Technical Parts Gram

Selecting the Correct Head Gasket for Caterpillar® 3406E and C15 Engines-

M-2245122

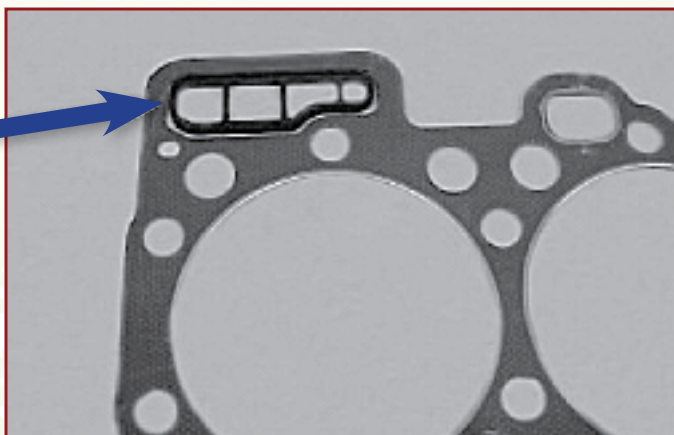
Two different head gaskets can be used on 3406E and C15 engines. The M-2245122 gasket has an additional steel core for increased rigidity and strength. See example above for difference in construction between the M-1539653 and M-2245122. It is important that the M-1422329 oil drain back seal be used with the M-2245122 gasket. The blue arrows in the example above indicate the location of the oil drain back seal. The M-1539653 gasket utilizes a molded in place integral seal. The M-2245122 gasket utilizes a drop in place M-1422329 seal.

SPECIAL NOTICE- TWO DISTINCTLY DIFFERENT CYLINDER HEAD CASTINGS ARE USED ON THESE ENGINES. THE LATER STYLE HEAD CASTING HAS SAW CUT RELIEFS BETWEEN CYLINDERS. EARLIER HEAD CASTINGS DO NOT HAVE THESE RELIEFS. CYLINDER HEADS **WITHOUT** SAW CUTS REQUIRE THE M-1539653 GASKET. CYLINDER HEADS WITH SAW CUTS REQUIRE THE M-2245122 GASKET.
